Upper Silver Creek Restoration Project Year 4 Monitoring Report

NCDMS Project ID Number – 94645

**Burke County, North Carolina
NCDMS Project ID Number – 94645**

Subject: Response to DMS comments on the Year 4 Monitoring Report Review for the Upper Silver Creek Stream and Wetland Restoration Project; Catawba River Basin - CU# 03050101; Burke County, North Carolina; NCEEP Project # 94645; Contract No. 003270

Looking at the Left Bank

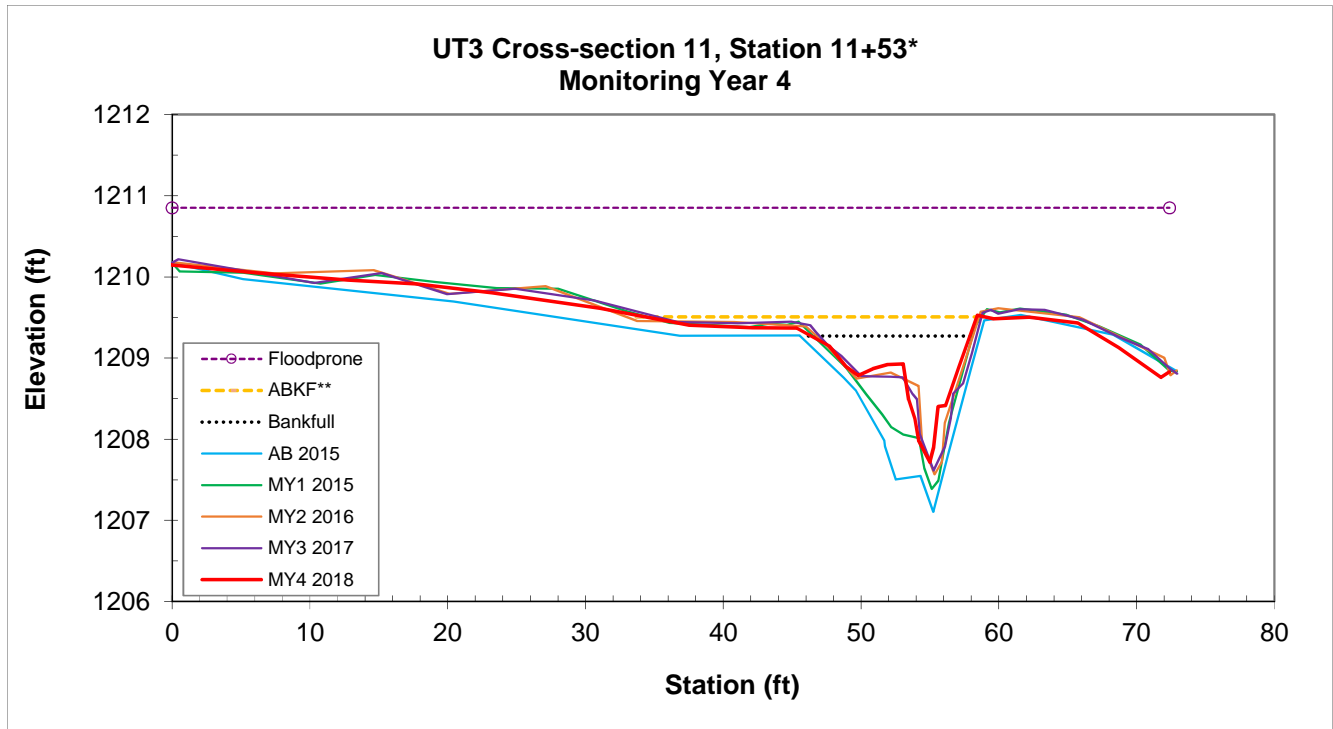
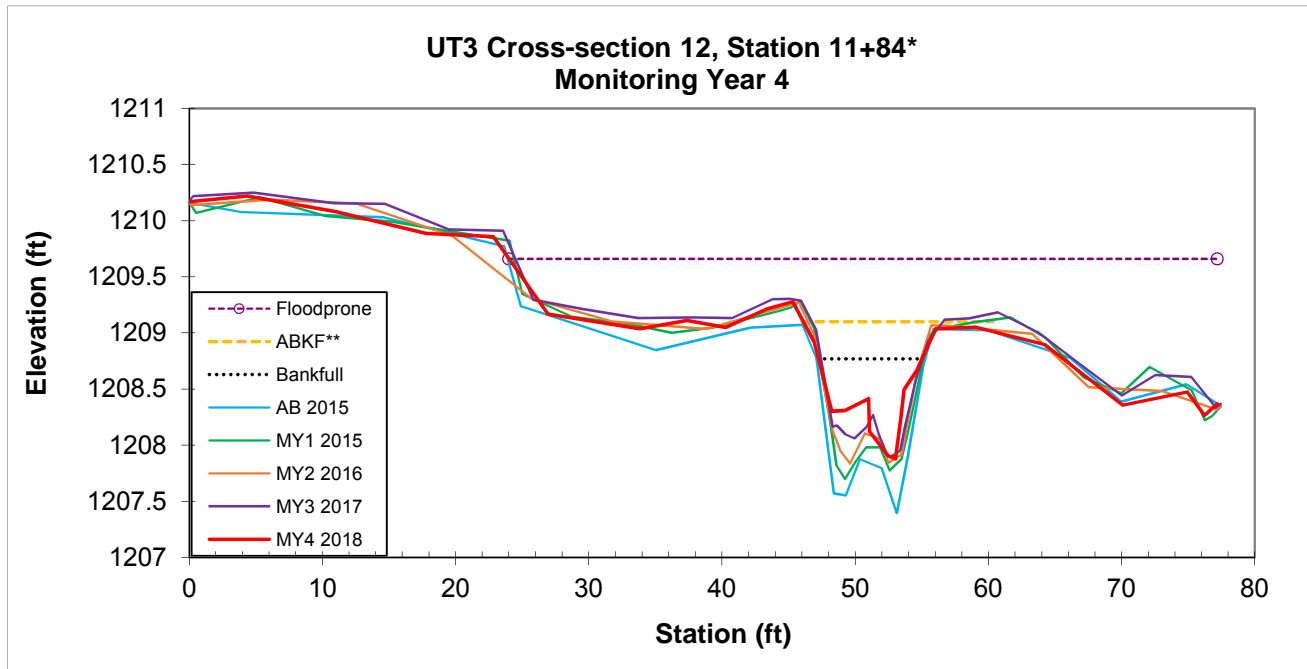
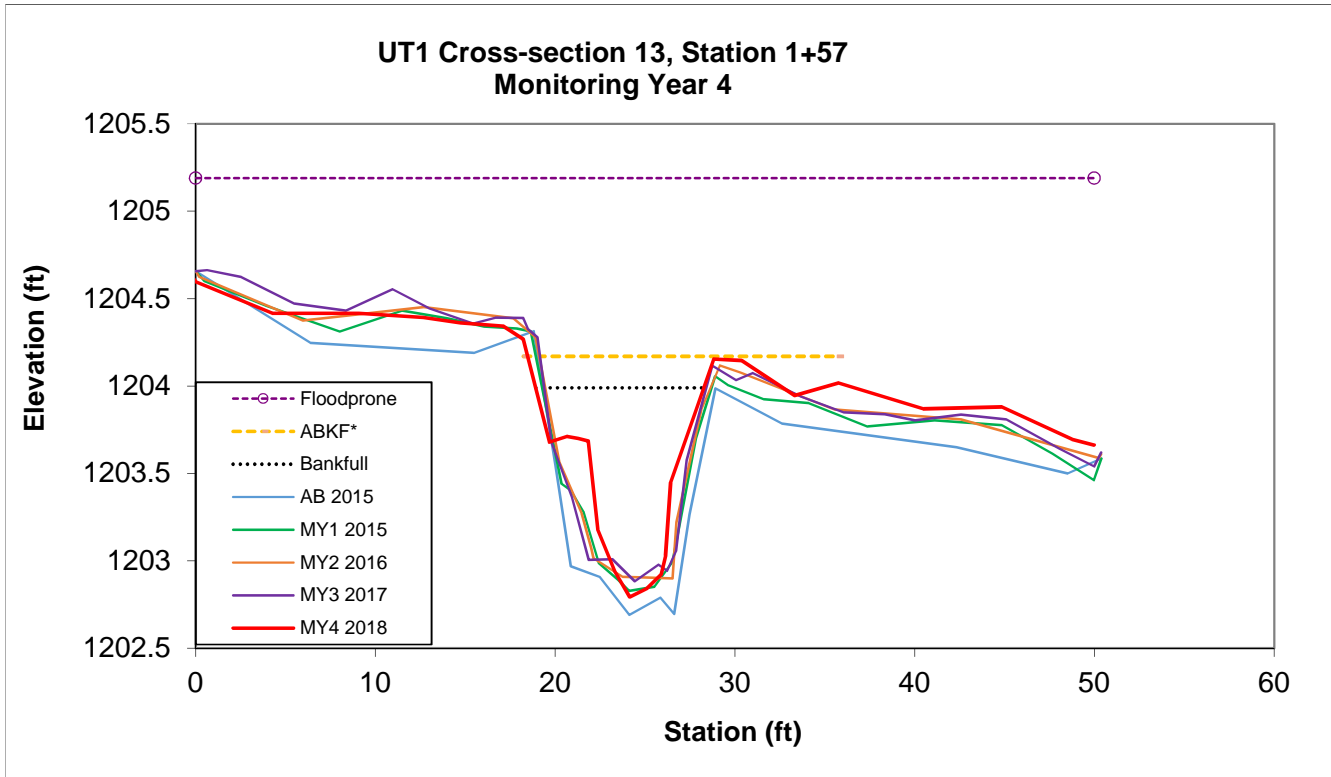
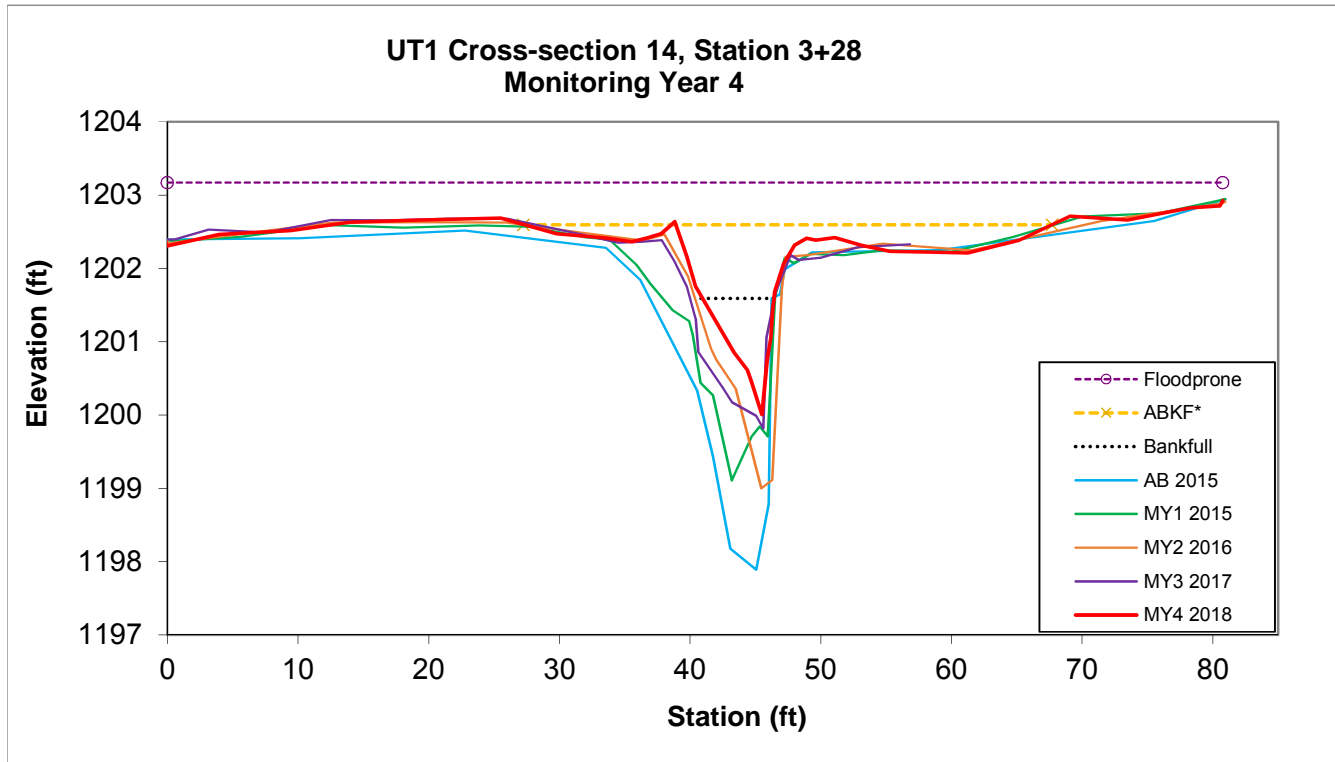
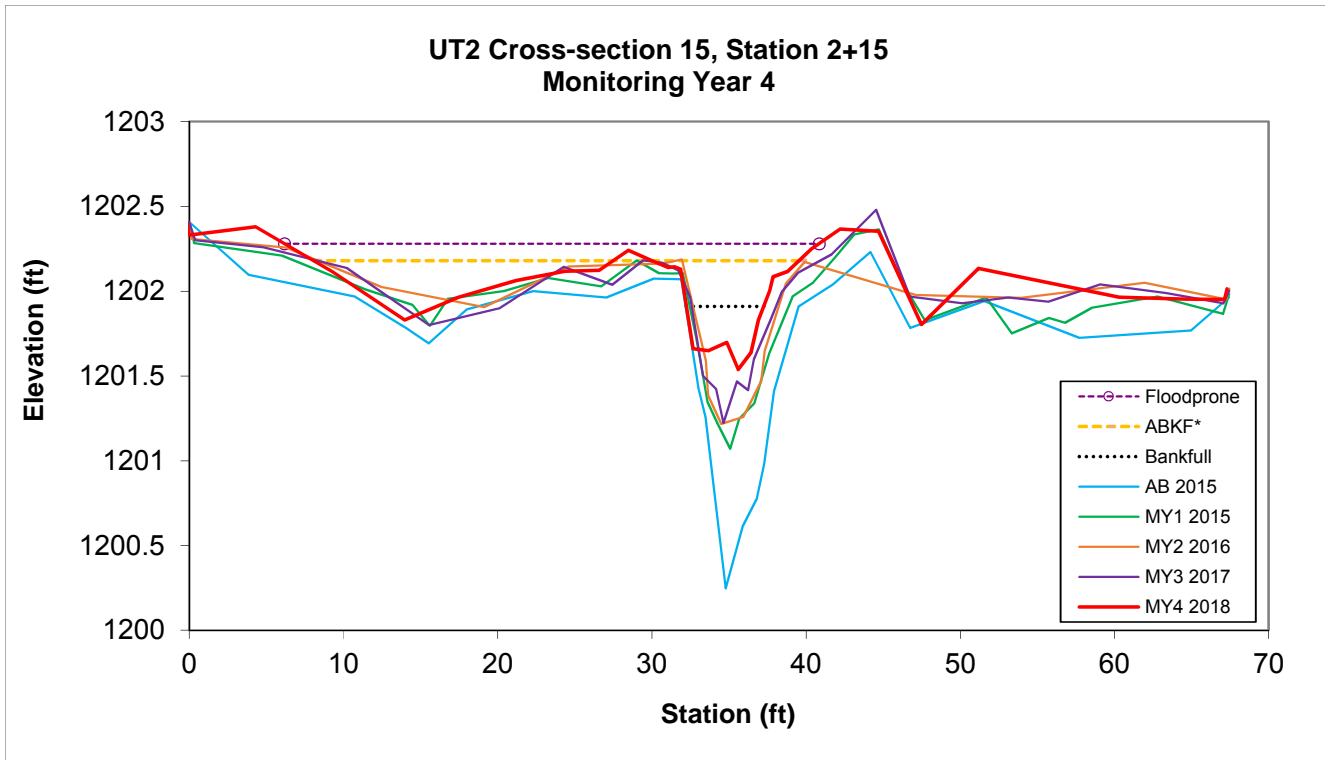
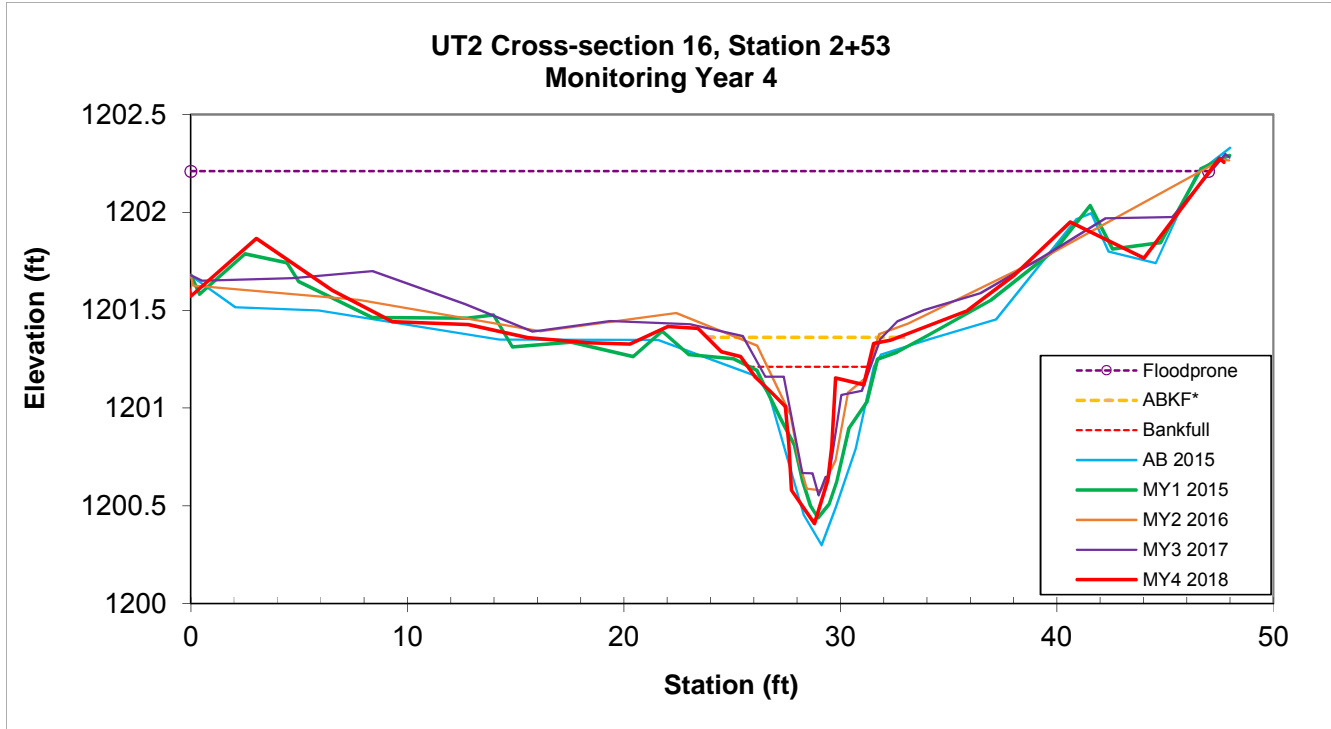
- Please confirm that the MY4 (2018) BHRs have been calculated based on the attached DMS technical guidance. The A_{bkf} reported in Table 11 does not show the same area being used as the asbuilt data. Please add note on table indicating that beginning in MY4, the bankfull elevation and channel cross section dimensions are calculated using a fixed A_{bkf} as described in the Standard Measurement of the BHR Monitoring Parameter provided by NCIRT and NCDMS (9/2018). Please update table and cross-section graphs as necessary with revised measurements.

The BHRs have been calculated based on our best understanding of the new methodology and additional input from the Raleigh NCDMS staff (Greg Melia and Jeff Schaffer). The A_{bkf} that is reported in Table 11 is the A_{bkf} for MY4 based on the MY0 bankfull elevation used in each report. The BH Ratio reported on each cross-section and in Table 11 is based on the A_{bkf} reported in the MY0 report and requested in the new guidance. This involves adjusting an elevation transect line until the MY0 cross-sectional area is indicated under that line (call this elevation ABKF). The BH Ratio is the ratio of the depth from the low bank of that monitoring year (call this TOB elevation) to that years thalweg and the depth from the ABKF to that years thalweg, BH ratio = $(TOB-TW)/(ABKF/TW)$, where TOB and TW are for the monitoring year

and ABKF is based on the MY0 A_{bkf}. All cross-sections and data shown in the tables are based on this methodology and updates have been made as requested.
